# APPROVED MINUTES

## January 19, 2017 Standards Committee Meeting

RE: Minutes from the January 19, 2017 Standards Committee Meeting

807-LTHI-06 TEMPORARY HIGHWAY ILLUMINATION DETAILS (WITH MARKUPS)

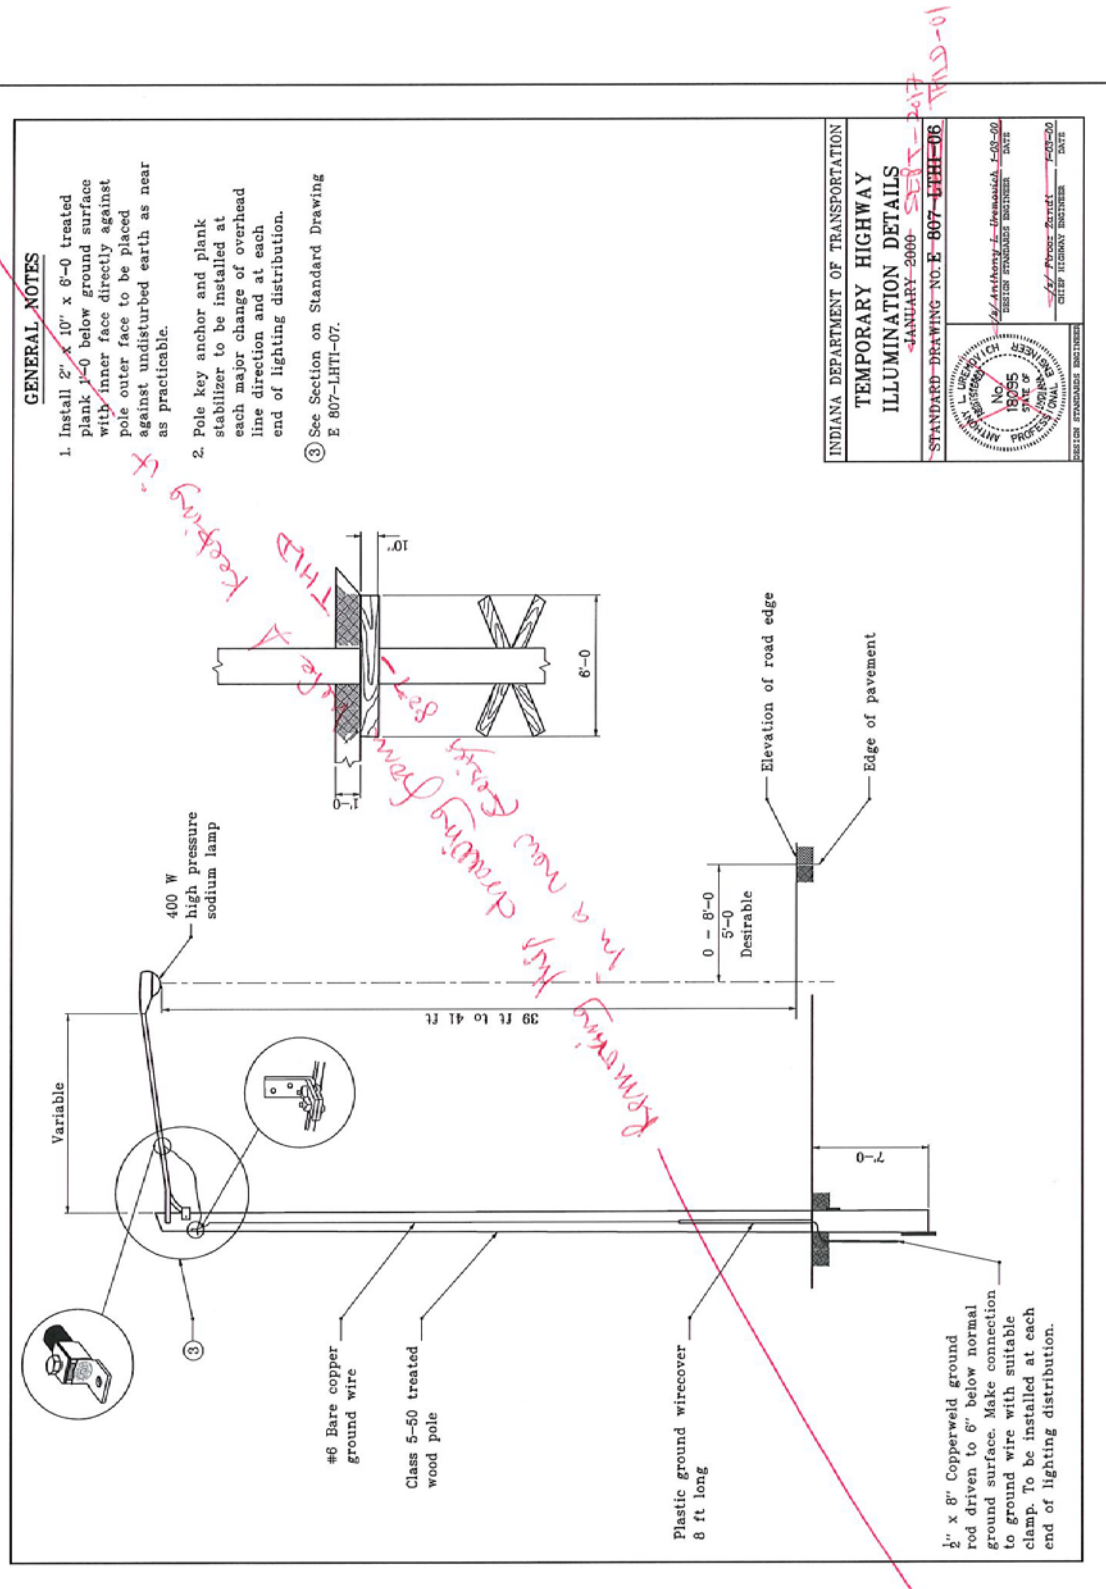
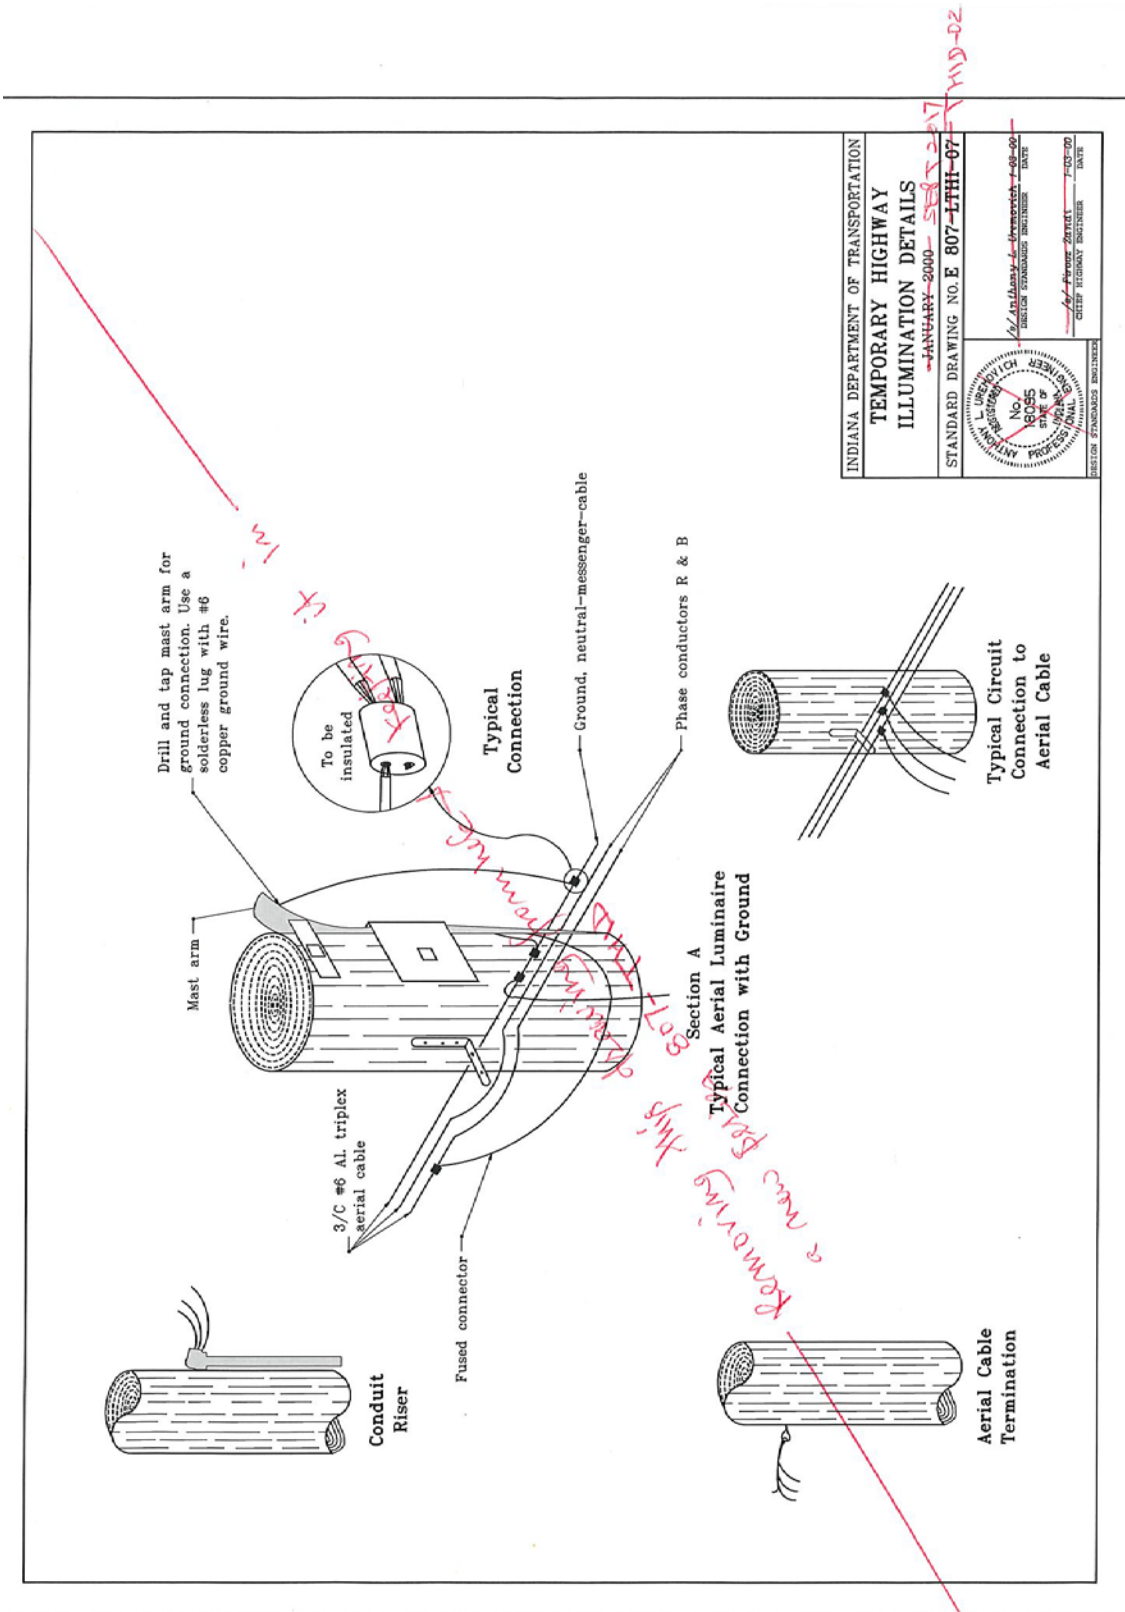
Move standard drawing 807-LTHI-06 and 07 for temporary highway illumination details from 807-LTHI series to a new series- 807-THID.
